# **Falcon Highlands South**

## **Preliminary Drainage Report**

**April 26, 2023**

**PUDSP-22-005**

EX-01

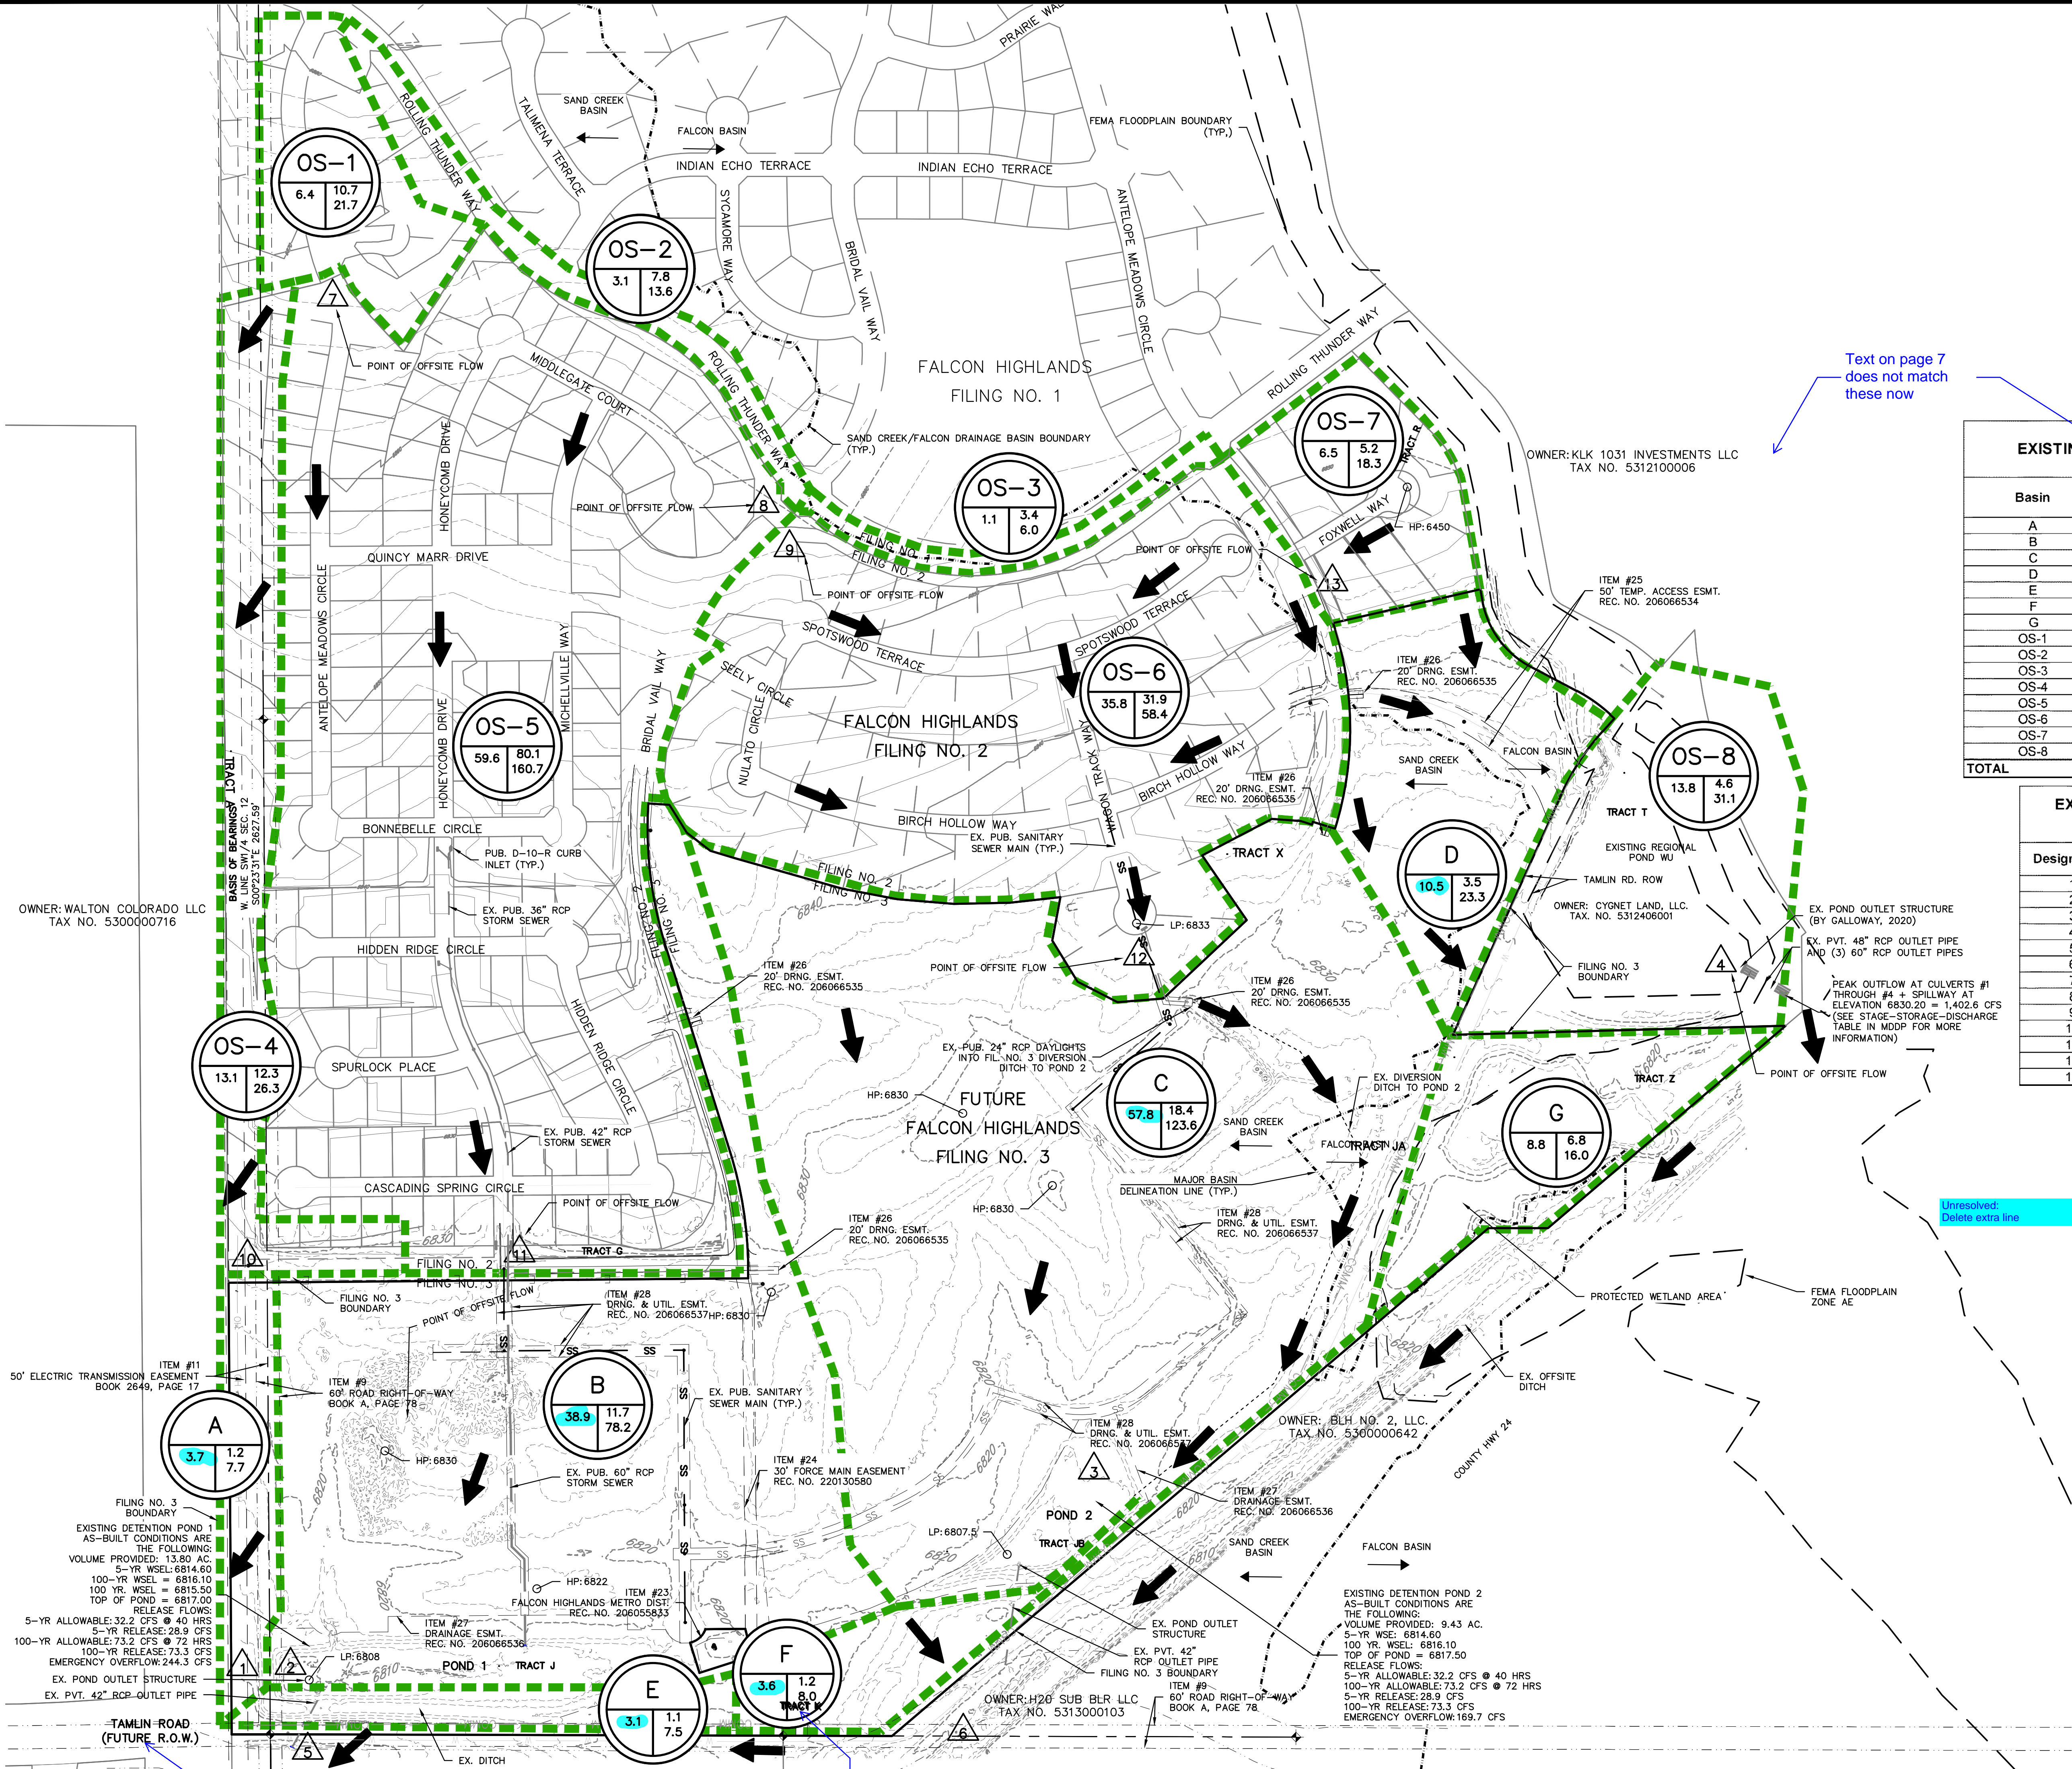
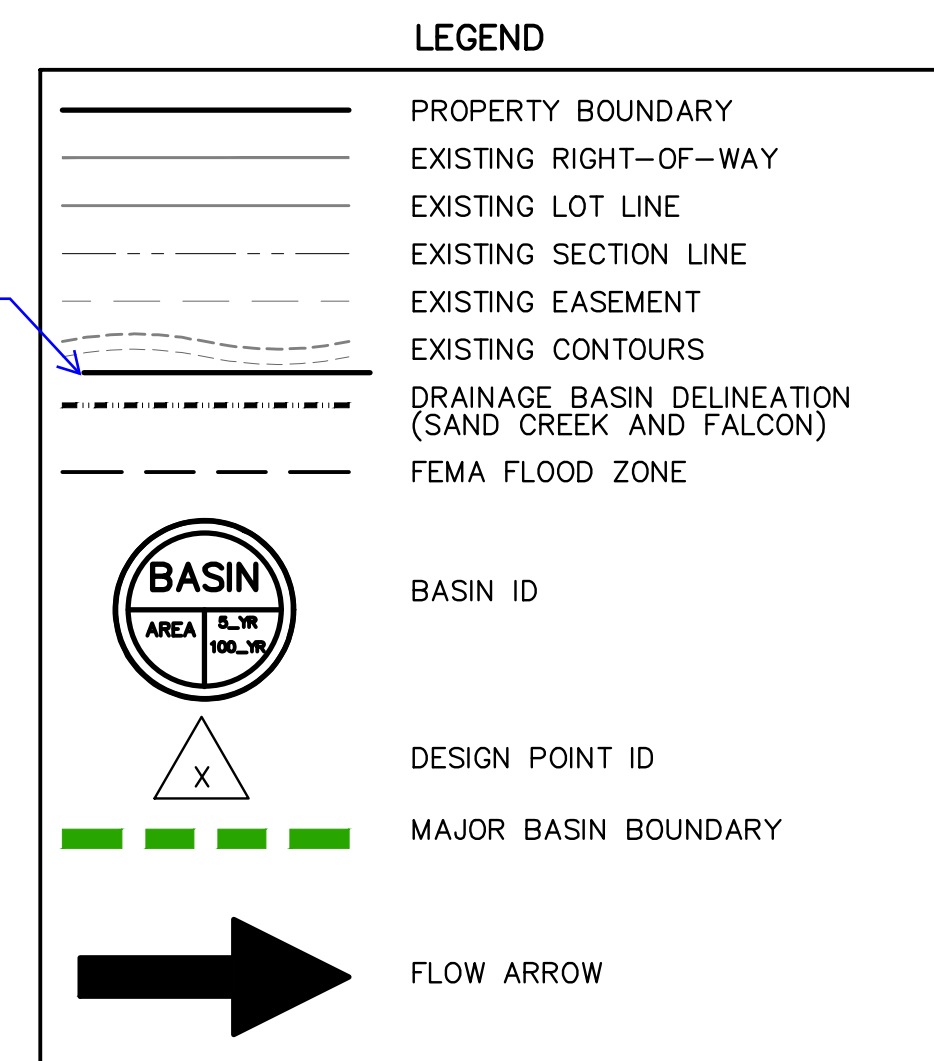
Text on page 7 does not match these now

Unresolved Delete extra line

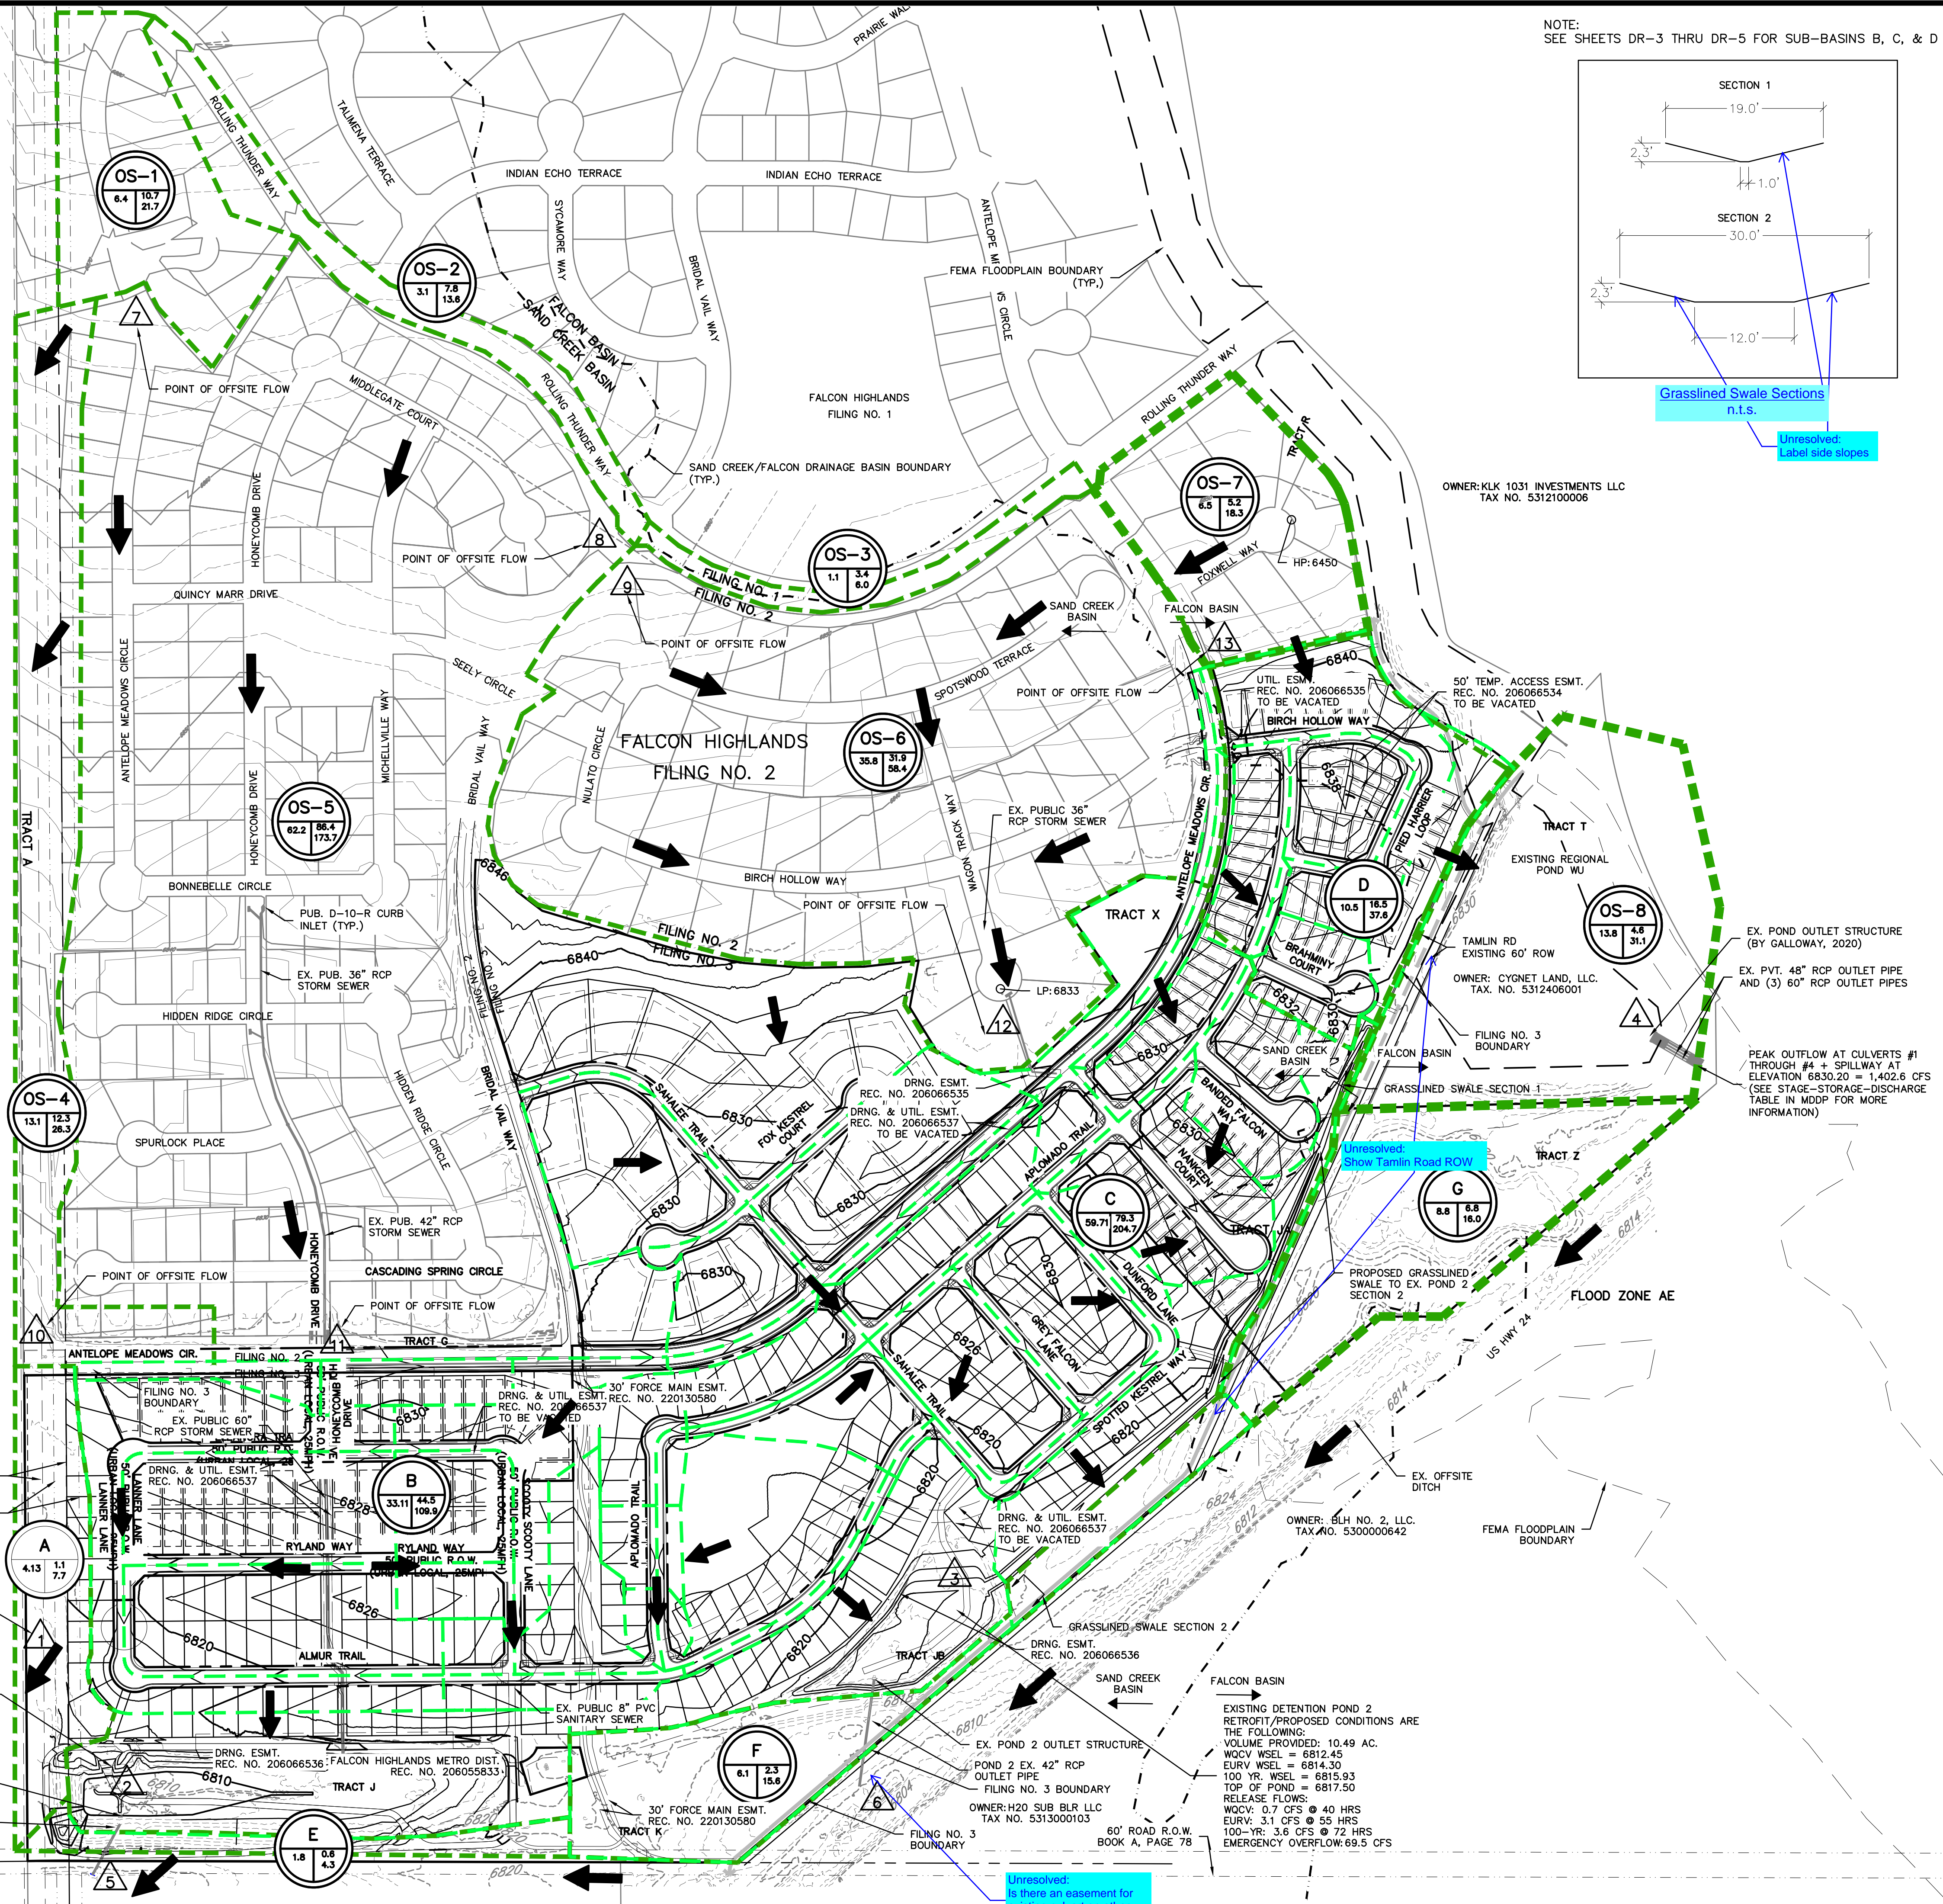
Something is missing or extra lines?
